LANDSCAPE PROOF OF EVIDENCE

COTMOOR SOLAR FARM LAND NORTH OF HALLOUGHTON, SOUTHWELL, NOTTINGHAMSHIRE

**PROPOSAL:
CONSTRUCTION OF A SOLAR FARM AND BATTERY
STATIONS TOGETHER WITH ALL ASSOCIATED WORKS,
EQUIPMENT AND NECESSARY INFRASTRUCTURE**

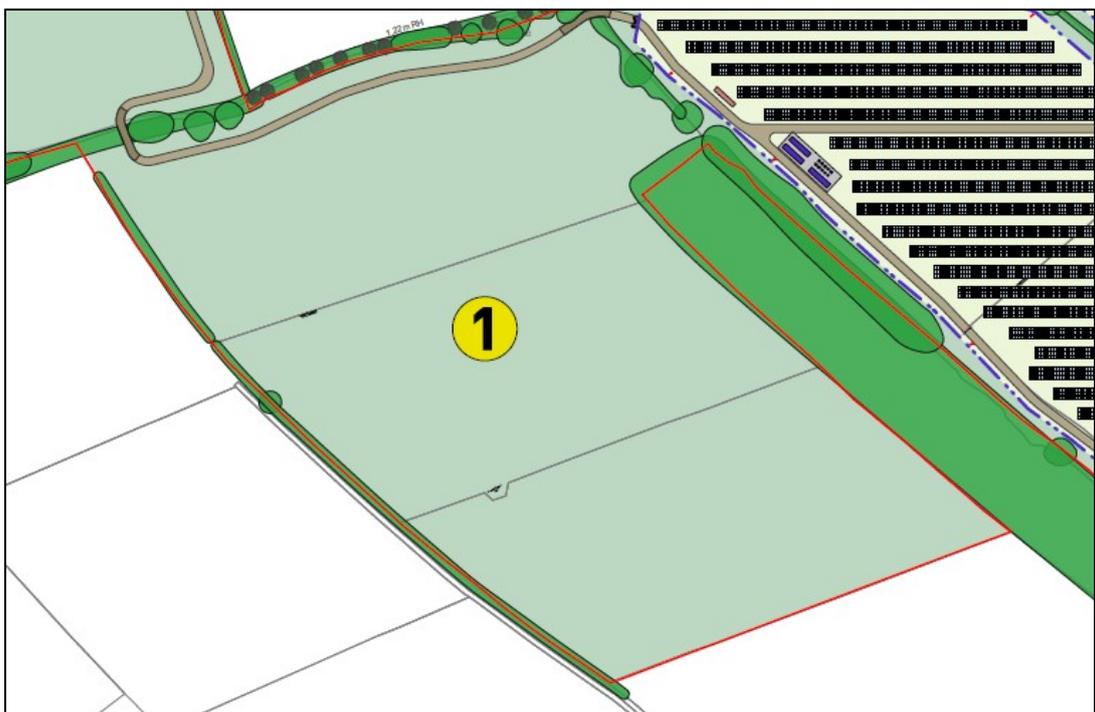
3.26 As illustrated, an amendment that has been made between the Revision L and Revision M of the Site Layout and Planting Proposals plan includes removing an area of solar panels and associated infrastructure from field F7. This amendment has been made to reduce the visual effects upon on road users at the western

extent of Halloughton and users of Public Right of Way (PRoW) Bridleway (reference: Halloughton BW3).

AMENDMENT 2: ADDITIONAL HEDGEROW TREES PROPOSED WITHIN EXISTING HEDGEROW

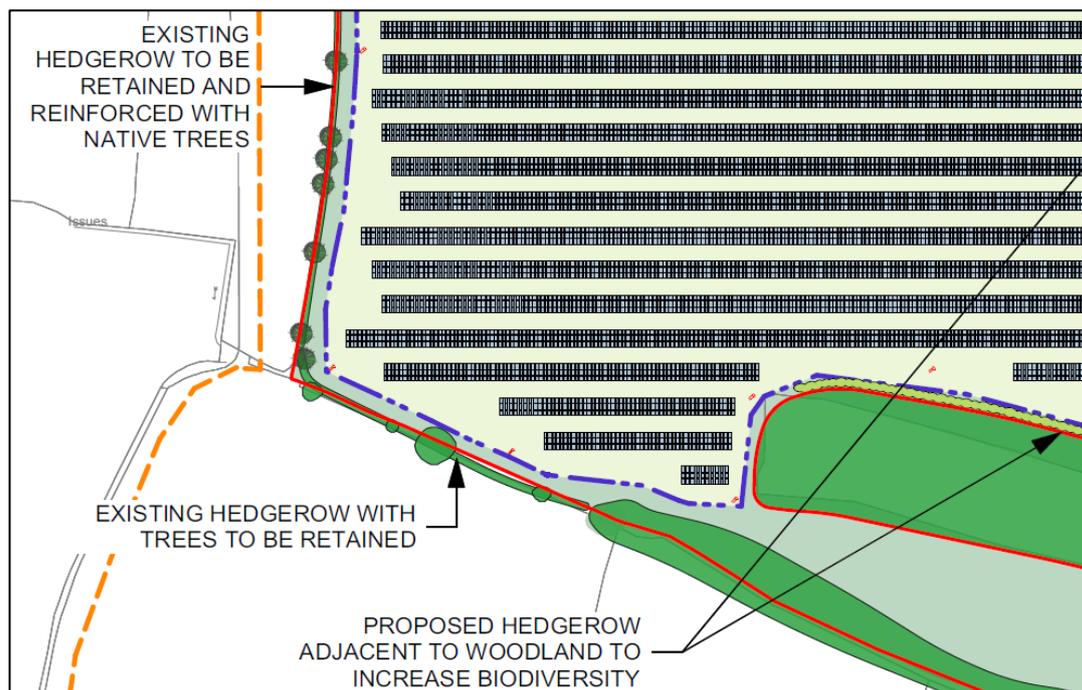
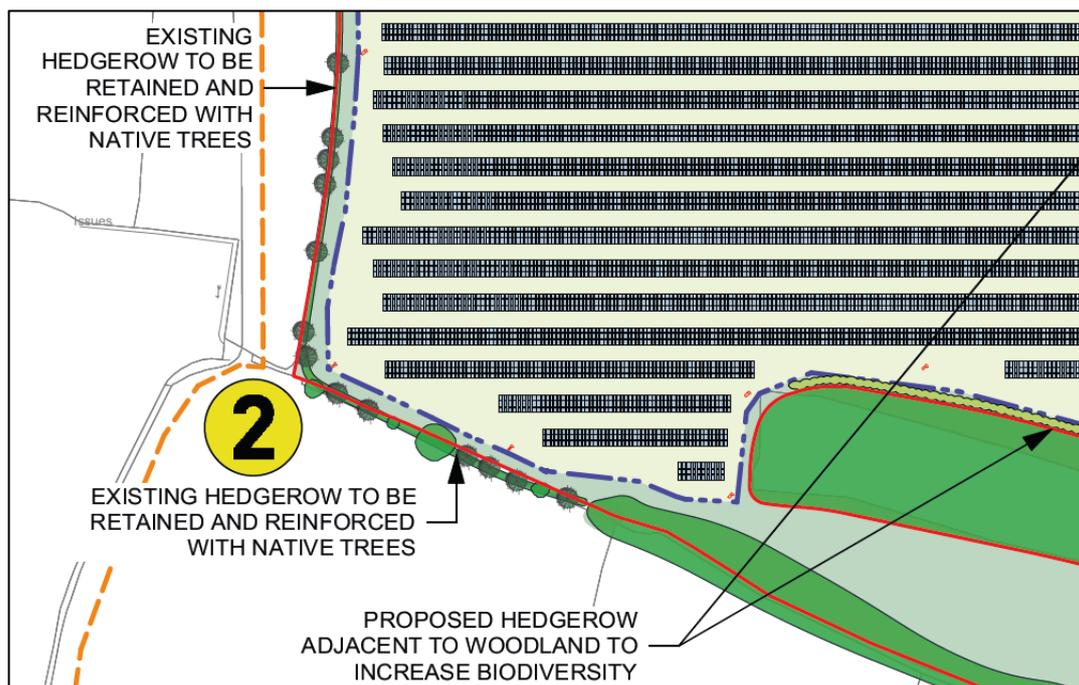
3.27 As illustrated on Revision M of the Site Layout and Planting Proposals plan below (CD A47), a belt of new trees are proposed within an existing hedgerow which encloses a section of the Site boundary to the southwest. These trees would be a mix of native standard trees which would aid in filtering and screening views of the proposals from locations on PRow Footpath (reference: Southwell FP42) to the southwest of the Site.

AMENDMENT 4: REMOVING PANELS AND ASSOCIATED INFRASTRUCTURE FROM THE NORTHEASTERN CORNER OF THE NORTHERN MOST FIELD TO FACILITATE THE CONTINUATION OF 'RE-WILDING OF THIS AREA

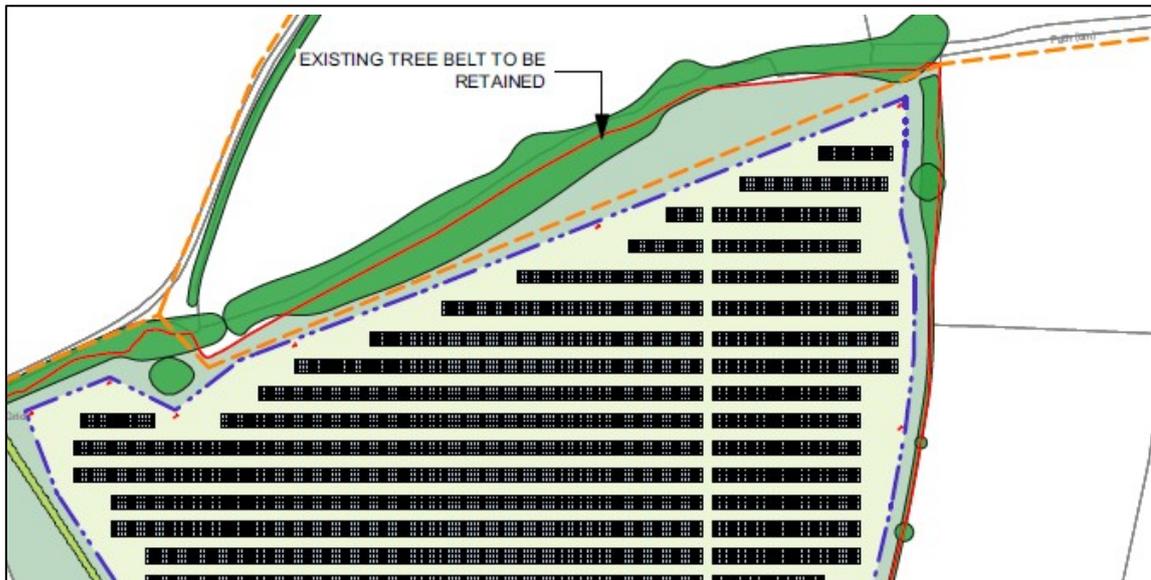
- 3.28 As illustrated below, a minor amendment as part of Revision M of the Site Layout and Planting Proposals plan (CD A47). This new hedgerow is proposed along the northern extent of the proposed built form, adjacent to the proposed security fencing. The hedgerow would be comprised of a mix of native hedgerow shrubs and semi-mature native trees and over time would aid in restricting and heavily filtering views of the proposals from locations along PRow Footpath (reference: Southwell FP43).

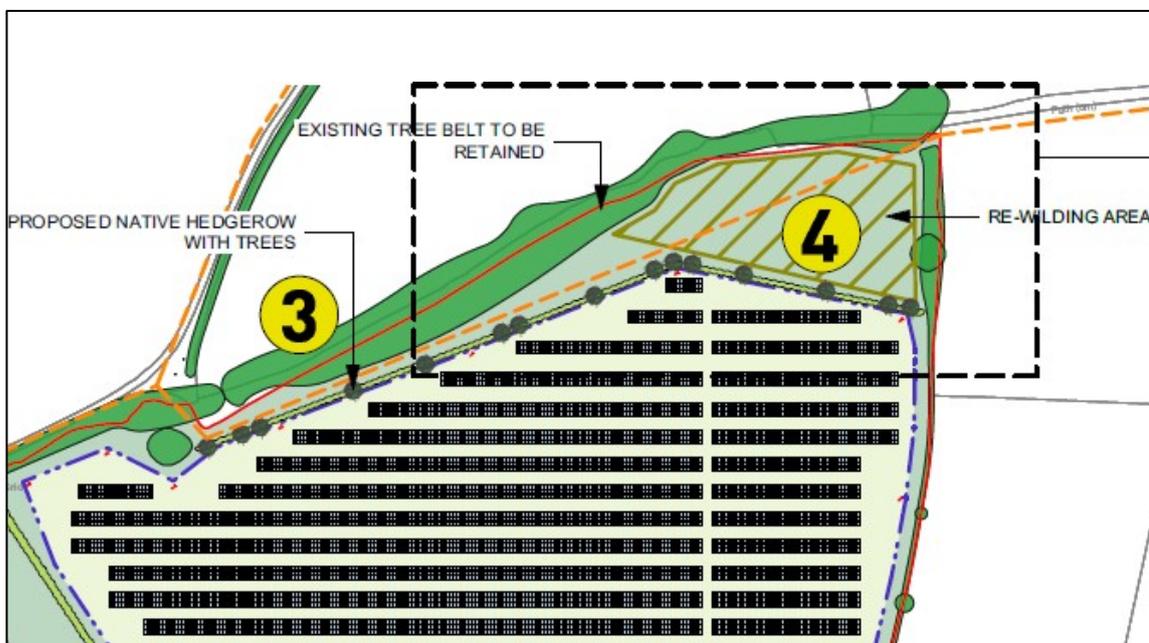
3.29 As illustrated on Revision M of the Site Layout and Planting Proposals plan (CD A47), the proposed solar panels and security fencing have been pulled back from the north-eastern corner of the field located to the east of New Radley Farm. Removing the proposal from this corner will enable an area of existing re-wilding to continue to establish.
